# BEACON FEN ENERGY PARK

Figure 6.31 Landscape Strategy Plan Part 3 (Change Request)

Document Reference: 6.4. ES Volume 3, 6.4.42c

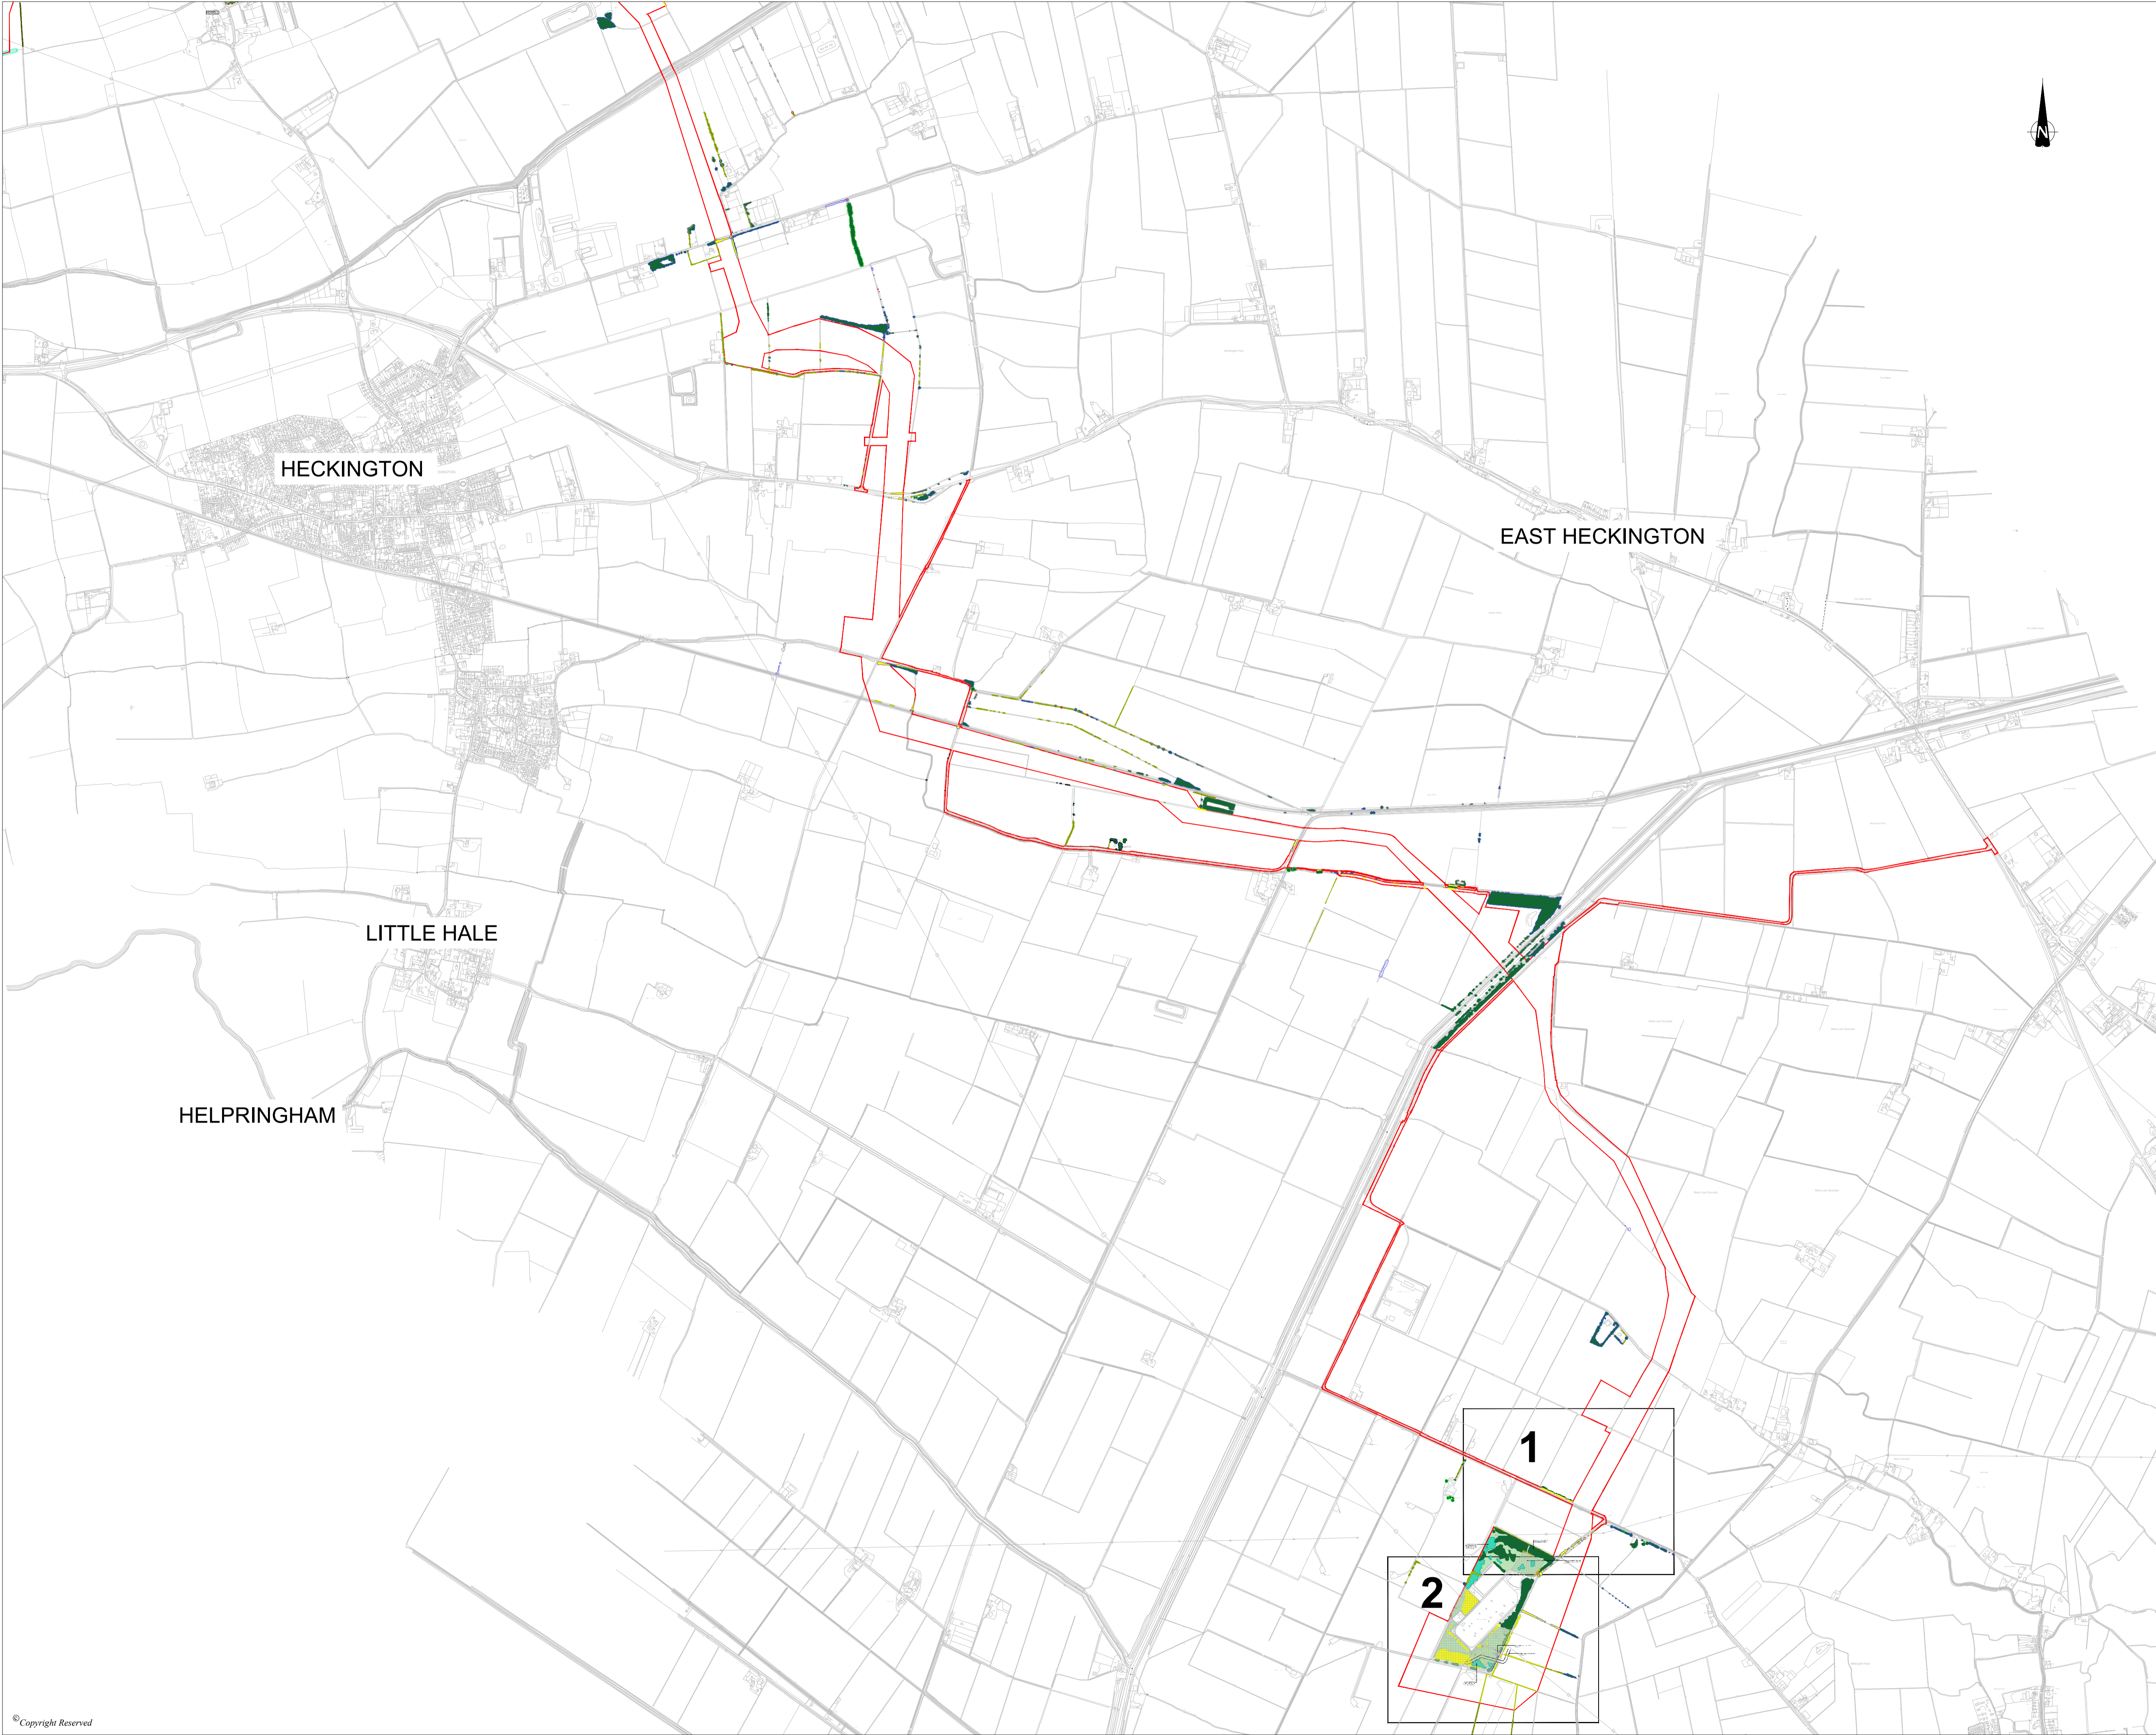
4	Revised annotation and aggregate / matting areas for construction added (Bicker Fen Substation)	17-12-25	MAB	DS	DS
3	Revised attributes and sheet numbers	11-12-25	MAB	DS	DS
2	Revised to incorporate enhancement proposals for Bicker Fen Substation	03-12-25	JAW/MAB	DS	DS
REVISION		DATE	DRAWN	CHECKED	APPROVED
CLIENT					
BEACON FEN ENERGY PARK LTD					
PROJECT					
BEACON FEN CABLE ROUTE CORRIDOR					
DRAWING TITLE					
FIGURE 6.31 LANDSCAPE STRATEGY PLAN CABLE ROUTE CORRIDOR OVERVIEW PLAN					
DRG No.	ST19595-082-CRC	REV	4	SUIT. CODE	
DRG SIZE	A1	SCALE	1:150,000	DATE	18/10/2023
DRAWN BY	JC	CHECKED BY	DS	APPROVED BY	DS
 PART OF SLR

FIGURE 6.31  
LANDSCAPE STRATEGY PLAN  
CABLE ROUTE CORRIDOR (Sheet 1 of 2)

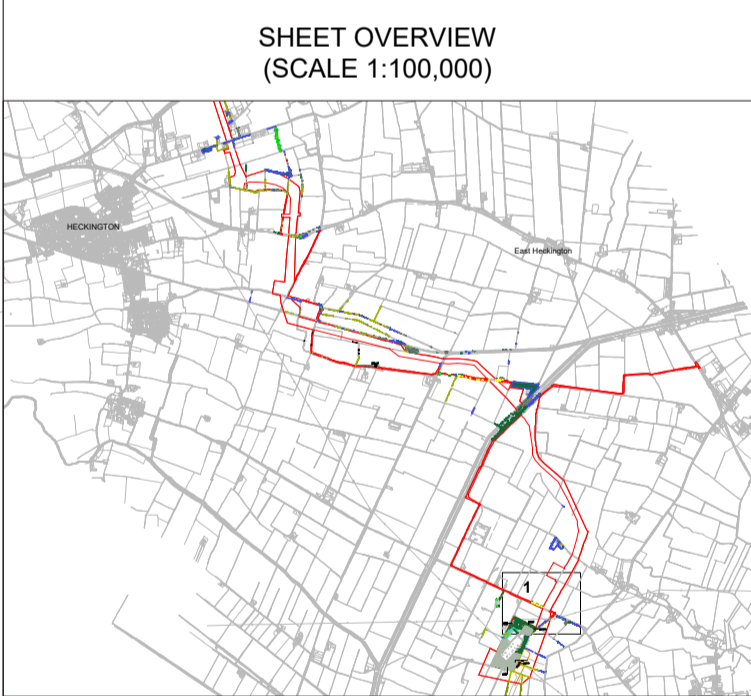
4	Revised annotation and aggregate / matting areas for construction added (Bicker Fen Substation)	17.12.25	MAB	DS	DS
3	Revised attributes and sheet numbers	11.12.25	MAB	DS	DS
2	Revised to incorporate enhancement proposals for Bicker Fen Substation	03.12.25	WYAM	DS	DS

FIGURE 6.31  
LANDSCAPE STRATEGY PLAN  
CABLE ROUTE CORRIDOR (Sheet 2 of 2)

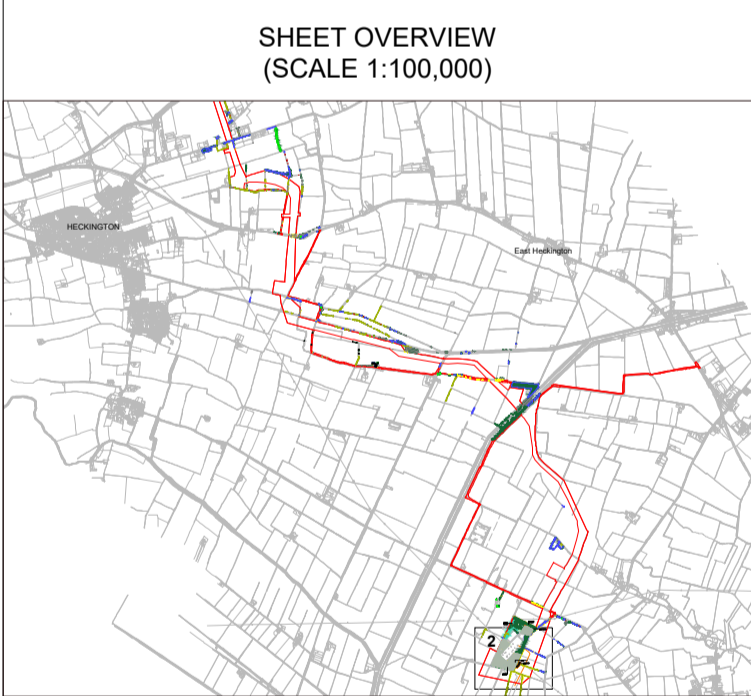
4	Revised annotation and aggregate / matting areas for construction added (Bicker Fen Substation)	17.12.25	MAB	DS	DS
3	Revised attributes and sheet numbers	11.12.25	MAB	DS	DS
2	Revised to incorporate enhancement proposals for Bicker Fen Substation	03.12.25	AWMAB	DS	DS
